RE: WM. H. ZIMMER NUCLEAR POWER STATION -
UNIT 1 - AMENDMENT 97 - SUBMITTAL OF
REVISION 14 TO THE FIRE PROTECTION
EVALUATION REPORT

WM. H. ZIMMER POWER STATIONINSTRUCTIONS FOR UPDATING YOUR FIRE
PROTECTION EVALUATION REPORT

FIGURE Q12-1
DIVISION 2 CABLE BUS ENCLOSURE
301333

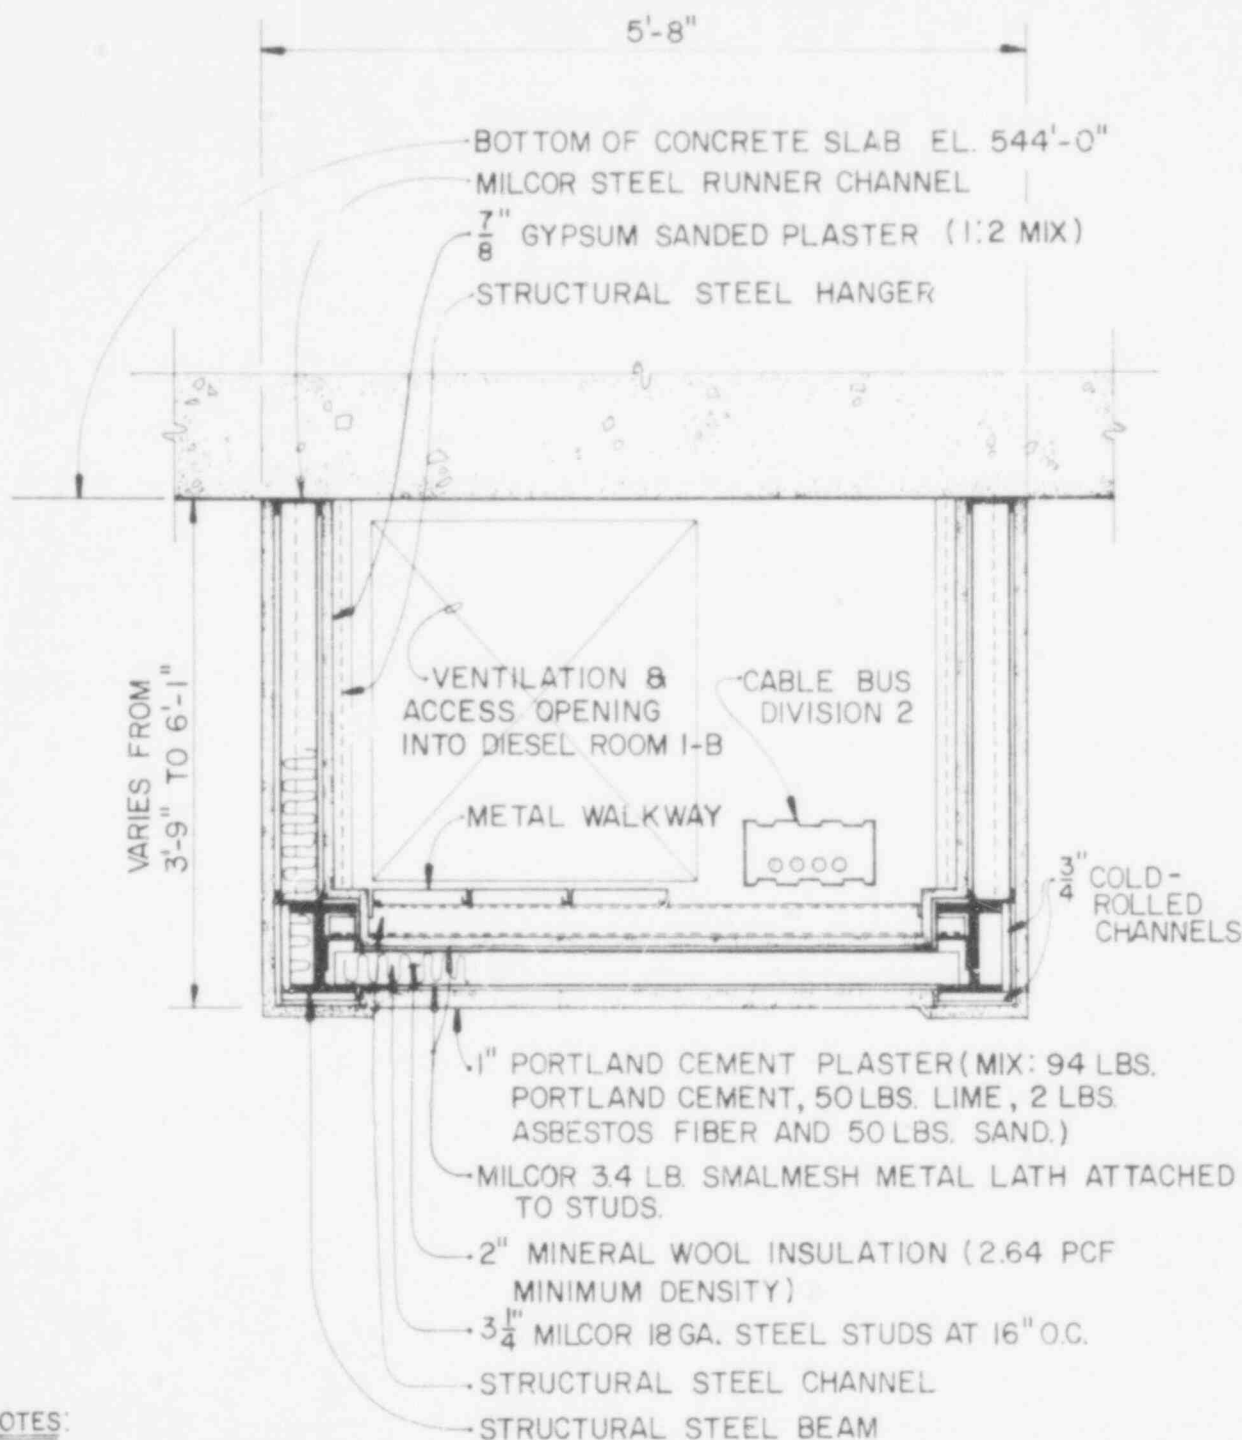
QUESTION 12 (SECTION 8.4.9, LIFT TRUCK ROUTE INTO AUXILIARY BUILDING)

- "a. Provide the results of an analysis of the effects on the redundant safety related cables and their associated systems of an exposure fire occurring in this area. Assume that the exposure fire is fueled by combustibles that are normally carried through this area by the lift trucks. If a fire should occur in this area that could not be extinguished by the sprinkler system or should the sprinkler system fail to operate, what are the consequences as they affect safe shutdown.

- "b. Provide the design criteria for the sprinkler system to be provided for this area.
- "c. This area is separated from the turbine building by a rated fire wall. A large opening is provided in this wall for the lift trucks to move between the turbine building and the reactor building. Describe the bulkhead type door, including the automatic or self-closing hardware to be provided and the fire rating of the door."

- a. Cable trays and cable bus for Division 2 (blue) which cross this area will be protected by a 1-hour passive fire barrier in addition to the automatic sprinkler system. The cable trays will be protected by Kaowool blanket material (see Question 7) which has been qualified by test.*

The Division 2 cable bus will be enclosed in a fire rated corridor which will connect the Division 2 diesel-generator room with its associated switchgear room on the opposite side of the lift truck route. Located in this corridor, the cable bus will be segregated from the lift truck route. The cable bus corridor is shown in Figure Q12-1.

- b. This area is protected by an automatic wet-pipe sprinkler system based on a design density of 0.30 gpm/ft^2 for a total flow of 484 gpm.

The sprinkler water for this system is a separate supply from the auxiliary building fire water supply header.
